APPROVED:	DATE:
L. B. FOSTER CO.	
<small>PITTSBURGH, PENNSYLVANIA 15220</small>	
FOR: MILLER CONSTRUCTION	
STATE OF VERMONT AGENCY OF TRANSPORTATION	
TOWN OF BRIDGEWATER, COUNTY OF WINDSOR	
VT. ROUTE 100A, BR14 PROJ. NO. BRS 0149 (4)	
MISC. DETAILS	
REV	DESCRIPTION
1	WPO 08/18/10 SDO339
2	RLP 09/11/10 LBE4

185 PREFAB DECK PANELS

DETAIL 1 (FROM LBE1)
SUPPLEMENTAL BARS NOT SHOWN

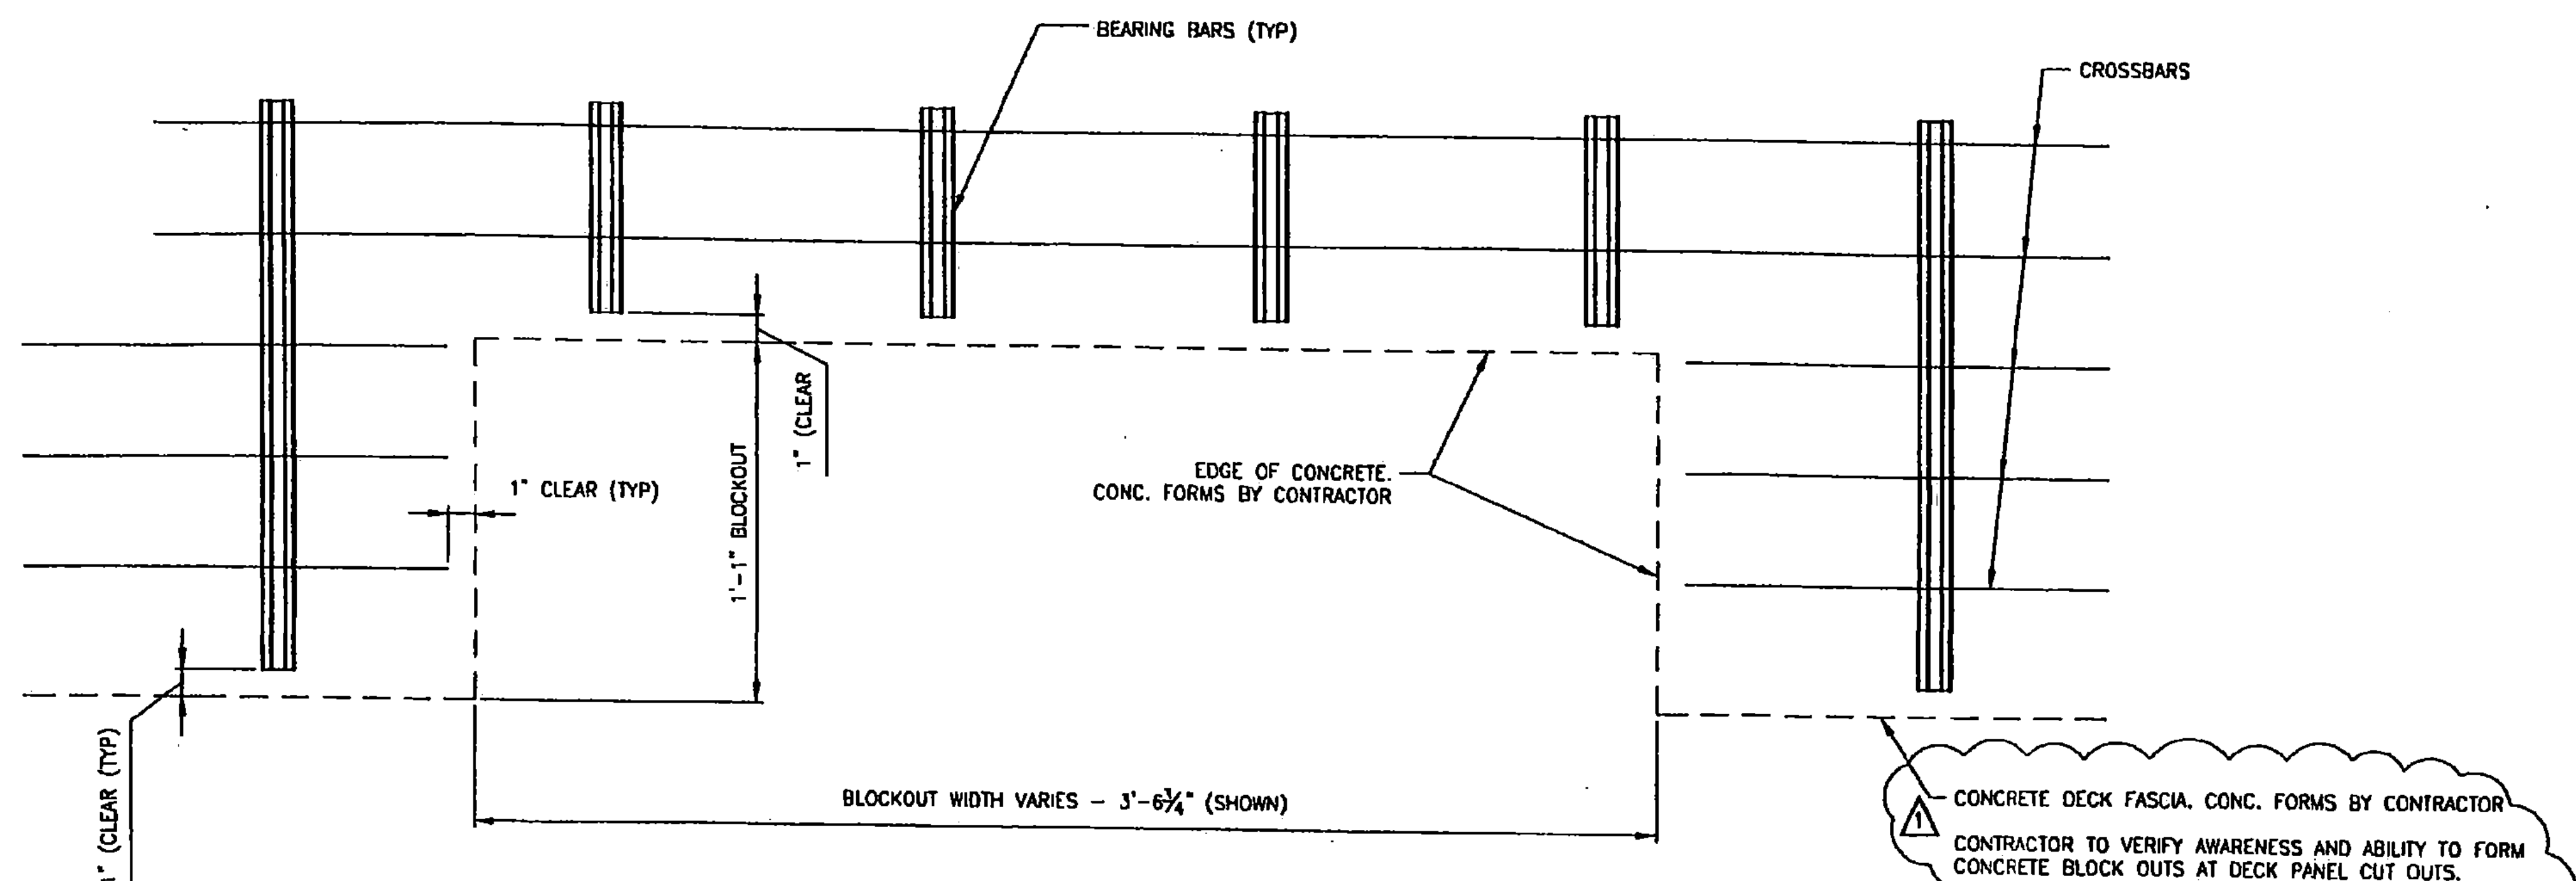
CONCRETE DECK FASCIA, CONC. FORMS BY CONTRACTOR
CONTRACTOR TO VERIFY AWARENESS AND ABILITY TO FORM CONCRETE BLOCK OUTS AT DECK PANEL CUT OUTS.

DETAIL 2 (FROM LBE3)

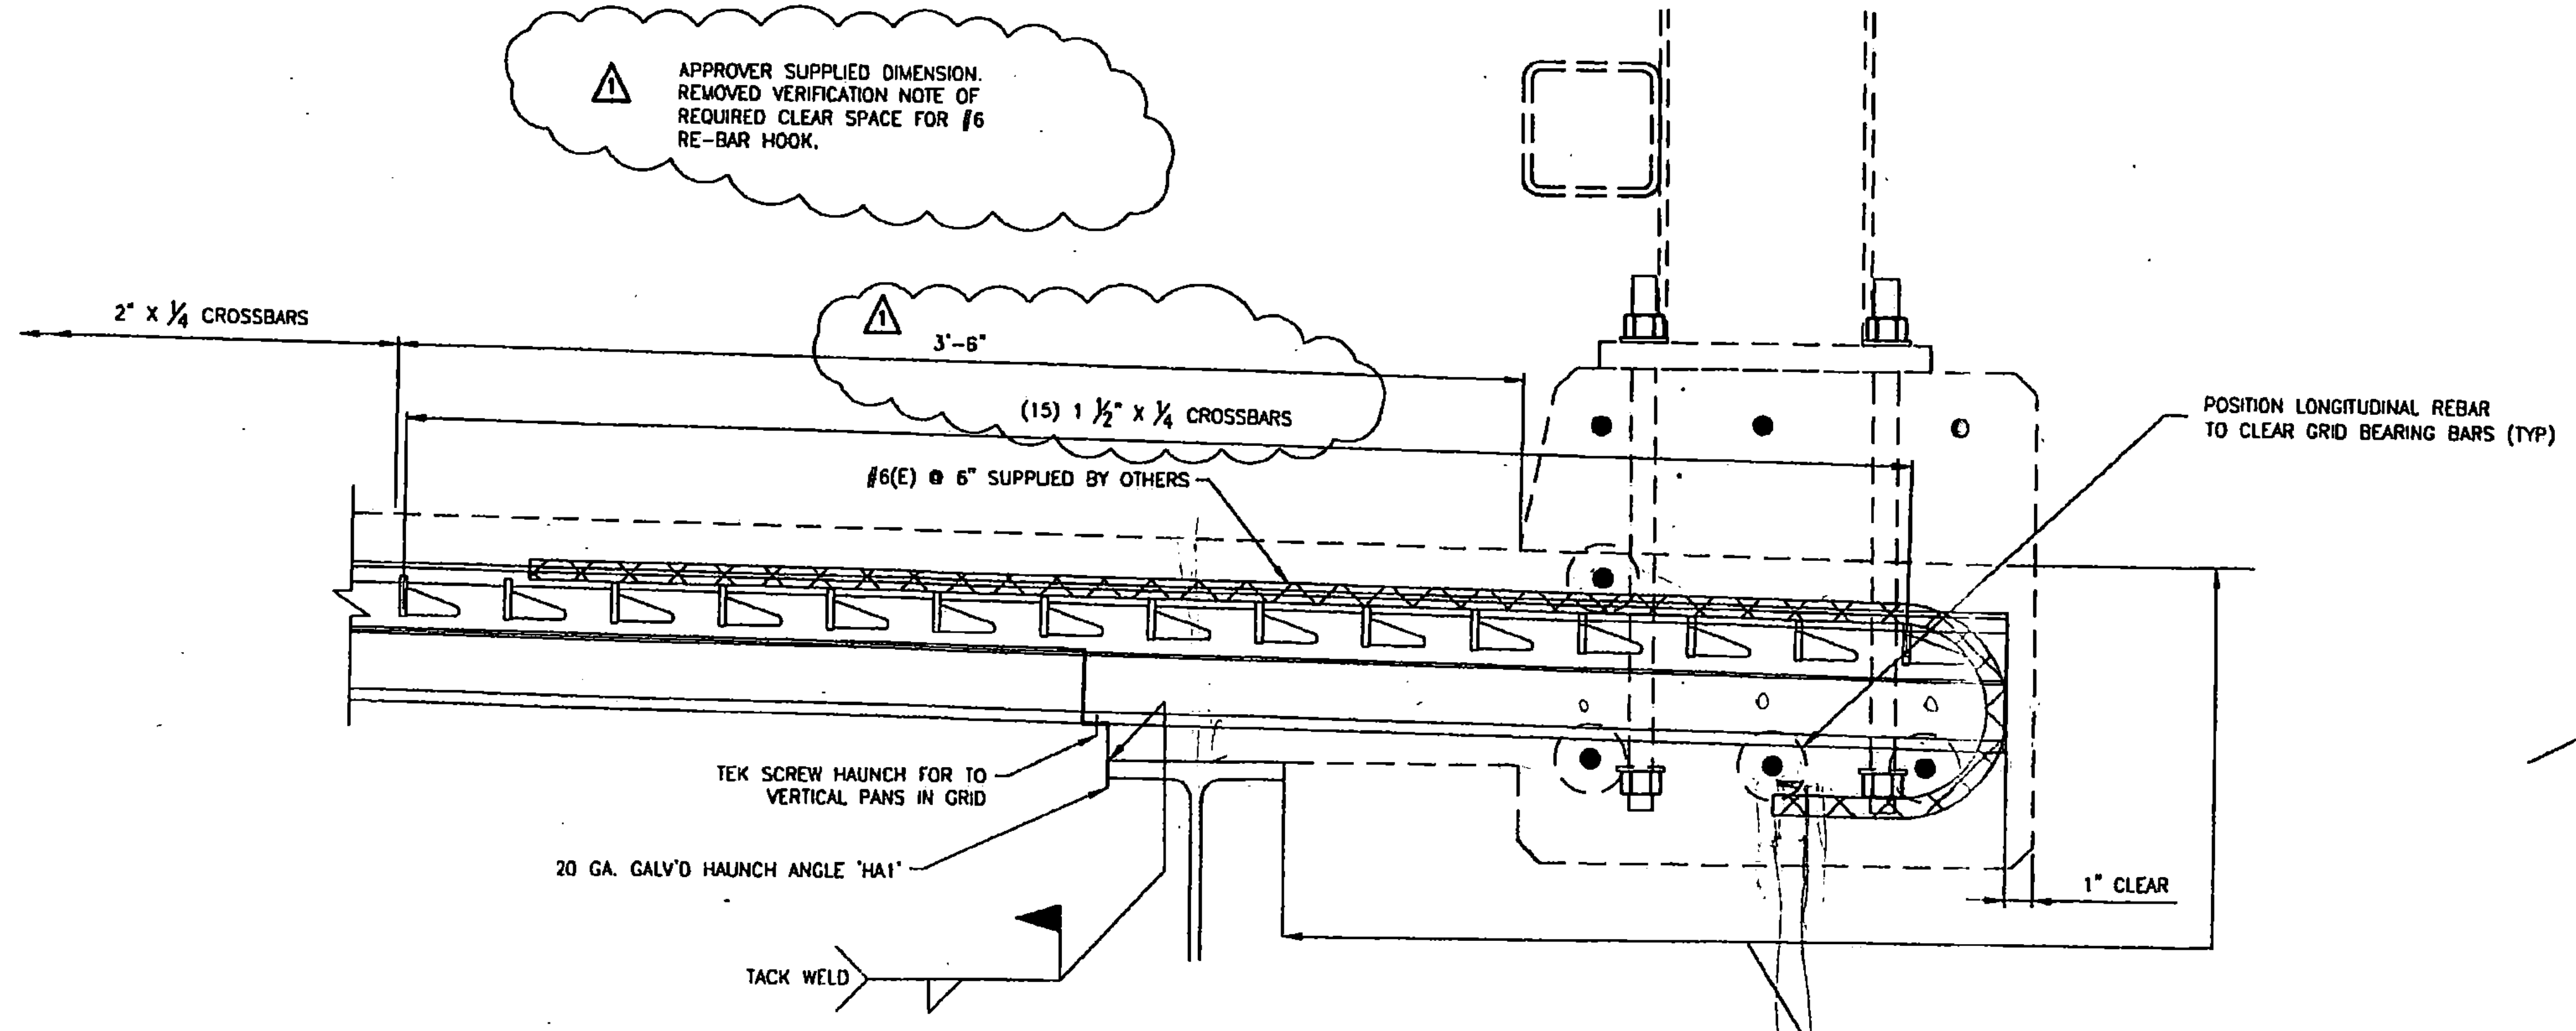
APPROVER SUPPLIED DIMENSION. REMOVED VERIFICATION NOTE OF REQUIRED CLEAR SPACE FOR #6 RE-BAR HOOK.
